Accessibility Survey

City of Downey Rives Avenue - Brookpark Avenue to Cul-De-Sac

Date of Inspection
6/22/2017

Prepared By
Disability Access Consultants
(800) 743-7067

Change in Level North of Luxor Street @ 33.939978788821, -118.145950734615

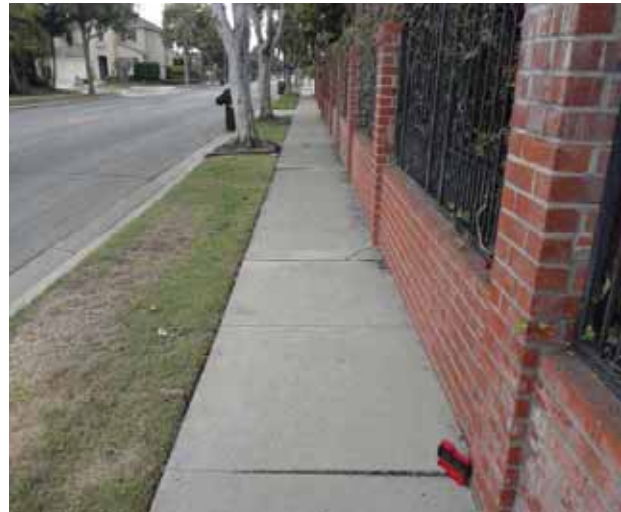
There is a change in elevation greater than recommended value.

On-Site Finding 0.50 inches

Ensure that the change in elevation is within the recommended value.

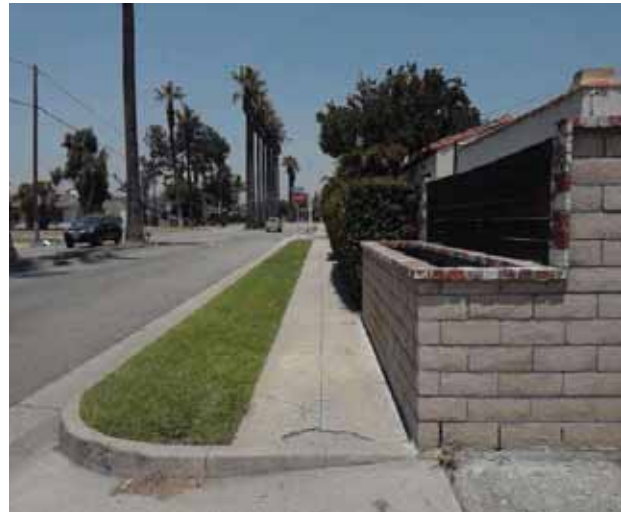
There is a curb on the designated path of travel.

On-Site Finding Not Compliant

Provide a compliant curb ramp.

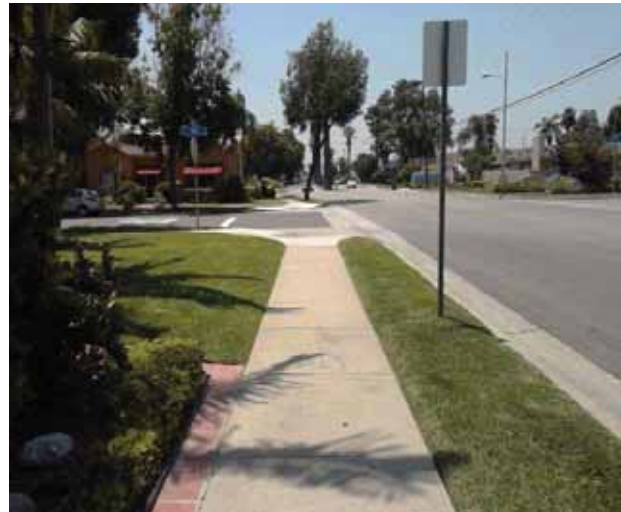
Sidewalk cross slope is not compliant.

On-Site Finding 3.90 percent for 40.00 feet

Repave the sidewalk surface with the recommended cross slope.

Change in Level South of Farm Street @ 33.951892906478, -118.136931806803

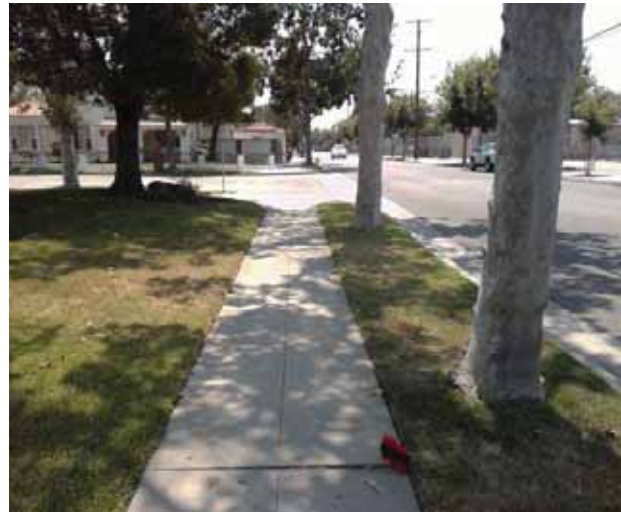
There is a change in elevation greater than recommended value.

On-Site Finding 1.00 inches

Ensure that the change in elevation is within the recommended value.

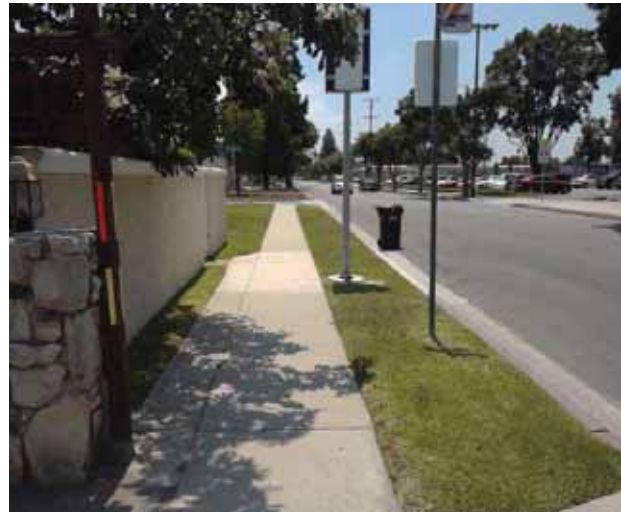
Sidewalk cross slope is not compliant.

On-Site Finding 3.20 percent for 92.00 feet

Repave the sidewalk surface with the recommended cross slope.

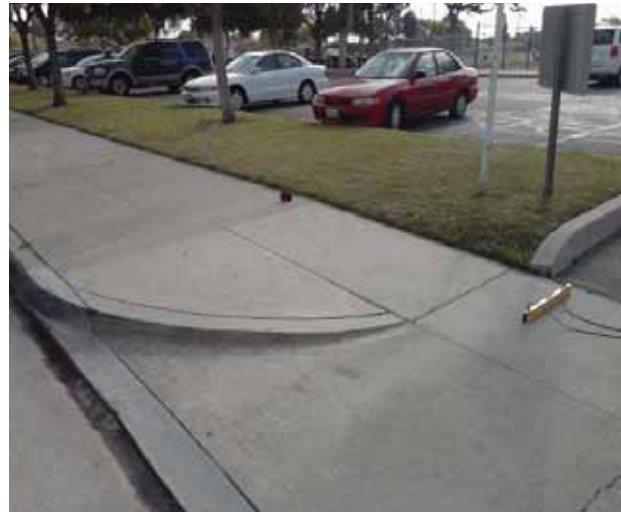
The transition from the top of the curb ramp to the walk, gutter, or street is abrupt.

On-Site Finding Not Beveled

Patch the transition area at the top of the curb ramp so that the transition is flush and free of abrupt changes.
